Re CBD AND SOUTH EAST LIGHT RAIL PROJECT ENVIRONMENTAL IMPACT STATEMENT

Figure 3-11: 2021 AM Peak CSELR Boardings and Mode of Access by Light Rail Stop⁸⁶

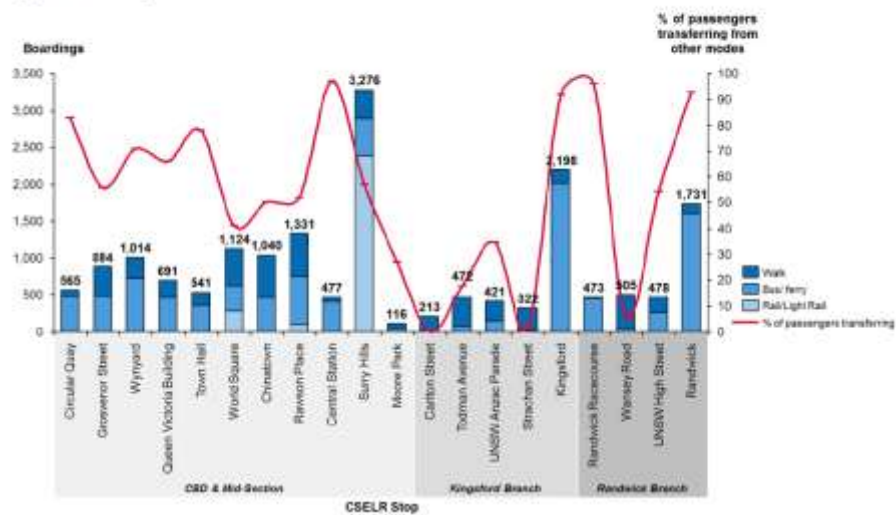
Page 117 of the EIS indicates 505 pedestrians join the inbound AM peak light rail at Wansey Rd (north) and 478 pedestrians inbound AM peak light rail join at Wansey Rd (South) or UNSW. There does not appear to be data provided in the EIS on the outbound AM peak. The Wansey Rd (South) or UNSW stop will have a large number of pedestrians alighting the light rail and stepping into the "shared" pedestrian cycleway. In the absence of any data, this may mean that the Wansey Rd UNSW High St stop has close to 1,000 pedestrian movements an hour competing with cyclists in a pathway no more than 2m wide!

With 500 pedestrians per hour waiting for light rail trams, accidents will occur until Randwick City Council is obliged to remove cyclists from the pathway. Some cyclists to avoid pedestrians will migrate from the dedicated off road cycle path to the single lane Wansey Rd. Pedestrian and / or cyclists fatalities are unfortunately imaginable with the current design.
